UNITED STATES  
NUCLEAR REGULATORY COMMISSION  
REGION IV  
1600 EAST LAMAR BLVD  
ARLINGTON, TEXAS 76011-4511

EA-12-023

Subject: FORT CALHOON STATION – NRC SPECIAL INSPECTION REPORT  
05000285/2011014; FINDING OF PRELIMINARY HIGH SAFETY  
SIGNIFICANCE

**Figure 1: Simplified 480 Vac Distribution Diagram**

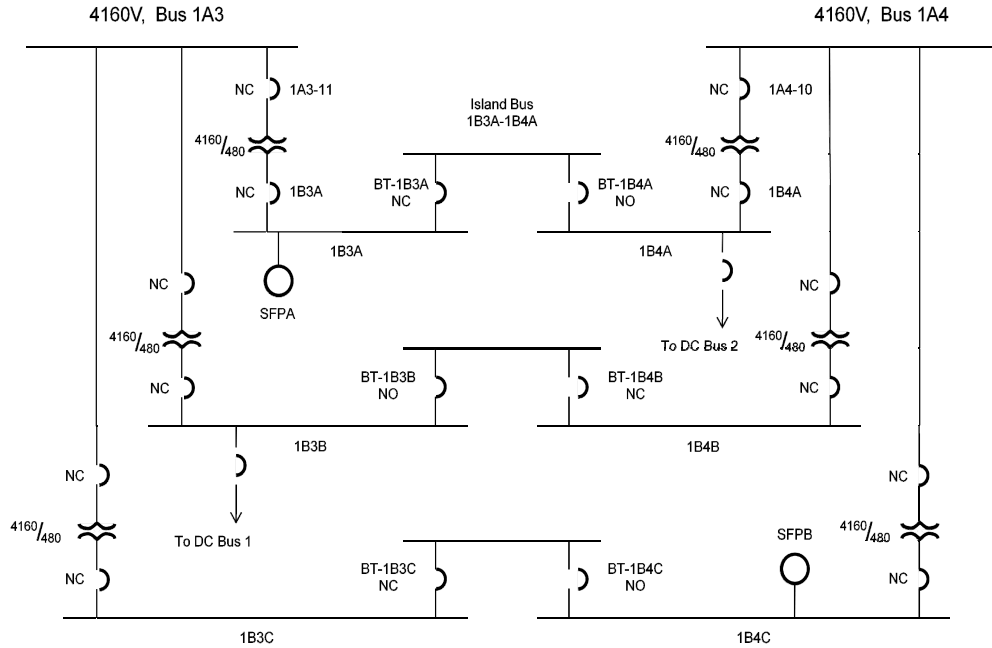
The team concluded that the licensee failed to maintain the electrical power distribution system design and licensing bases. The system was designed to provide two redundant, electrically and physically independent distribution trains of electrical power to safety-related loads during anticipated operational occurrences, design basis accidents, and external events. The design basis included provisions to limit fire damage to one train of the electrical distribution system, as described in Section 8.1.1 of the Updated Safety Analysis Report.

The safety-related 480 Vac distribution system arrangement is illustrated in Figure 1 of Attachment 4. The nine 480 Vac load centers were comprised of AKD-5 low voltage switchgear. The load centers were single-ended units with a delta-delta connected power transformer on one end providing the step down function from 4160 Vac to 480 Vac. The system consisted of six main buses and three island buses. The island bus sections were connected to one of the adjacent bus sections by a normally closed bus-tie circuit breaker. The other bus-tie breaker was kept open and electrically interlocked to prevent cross-connecting the 4160 Vac buses. Three load centers were supplied by the 1A3 bus; three load centers were supplied by the 1A4 bus.

**Figure 2: Simplified 125 Vdc Distribution Diagram**

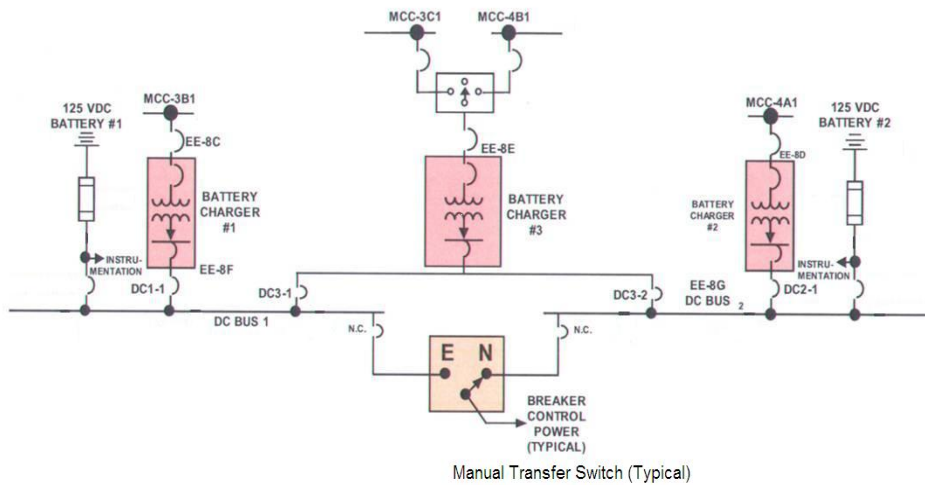
The ungrounded 125 Vdc distribution system, illustrated in Figure 2 of Attachment 4, consisted of three battery chargers, two storage batteries, two main distribution panels, manual transfer switches and other distribution equipment necessary for operation of the plant. The dc control power for each 4160 Vac and 480 Vac load center was fed via manual transfer switches, which allowed manual selection of either dc train as the source of control power to the buses. The manual transfer switches were designed with both trains of dc power in a common enclosure, with the normal and emergency supplies to the manual transfer switches fed from their respective dc buses via independent circuit breakers that were designed to provide selective fault protection and train separation.

During the event, ground alarms were received in the control room for both dc buses due to extensive damage inside load center 1B4A. Battery charger #2 was de-energized, and battery charger #3 had to be manually aligned to power dc bus #2. The team questioned the cause for the grounds, what affect the grounds had on the operability of the dc system, and what separation criteria the design was required to meet.
